SUBJECT: NuScale Power, LLC Supplemental Response to NRC Request for Additional Information No. 164 (eRAI No. 8935) on the NuScale Design Certification Application

Enclosure 1: NuScale Supplemental Response to NRC Request for Additional Information eRAI No. 8935

NRC Question No.: 03.07.02-24

**Figure 5.0-3: NuScale Horizontal Certified Seismic Design Response Spectra - High Frequency
5% Damping**

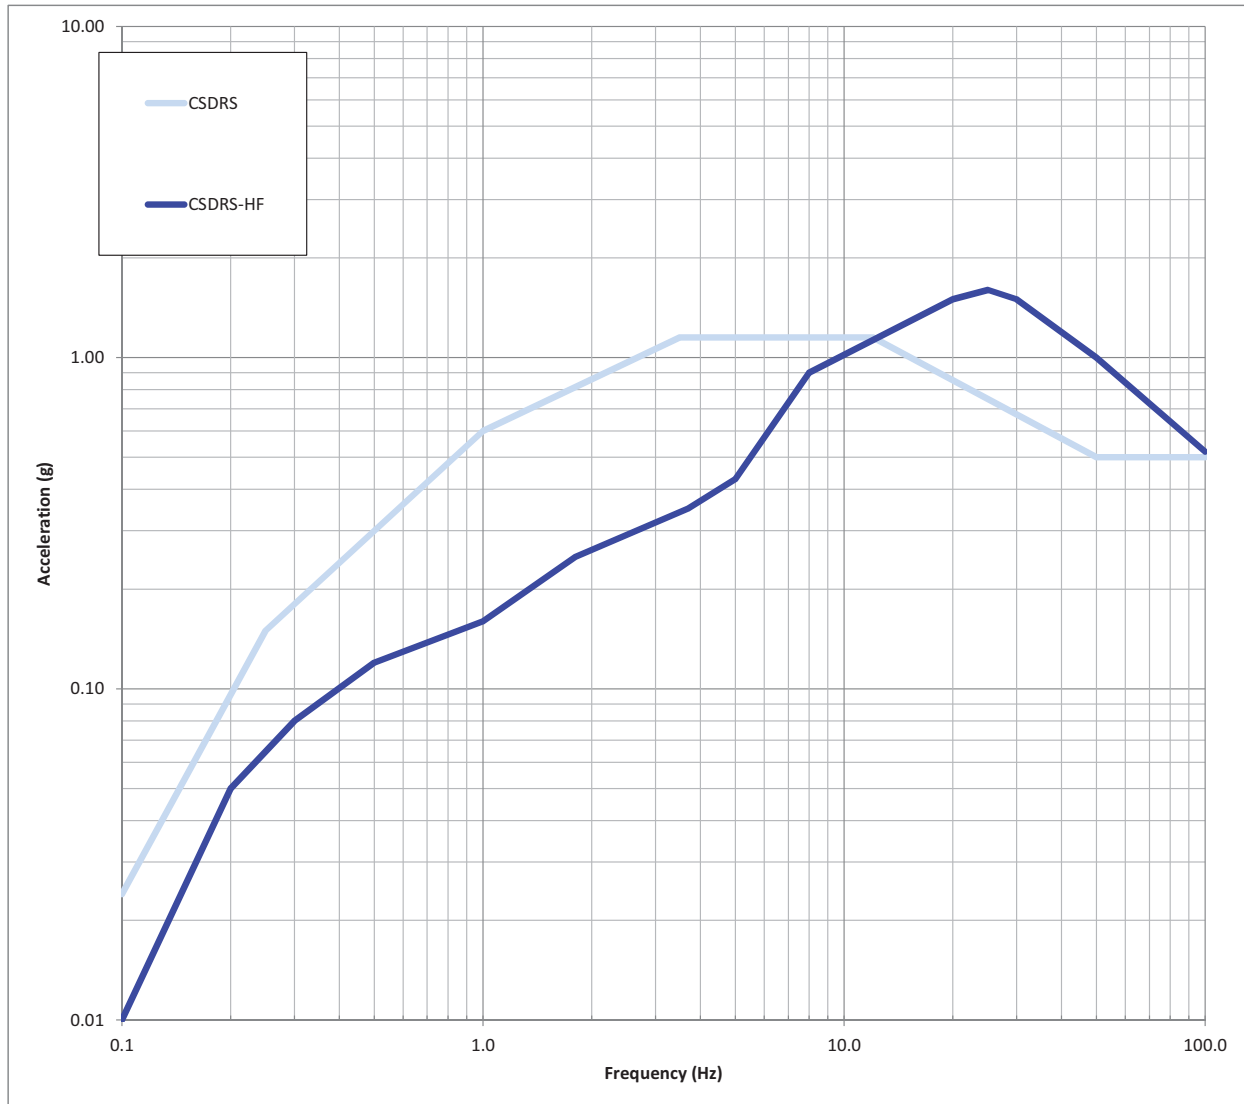
Notes have been added to FSAR Tier 1, Figures 5.0-3 and 5.0-4, and Tier 2 Figures 3.7.1-3 and

3.7.1-4 to clarify the basis of the “design basis seismic loads” for applicable SSCs.

Note: CSDRS-HF is evaluated for the RXB and CRB only
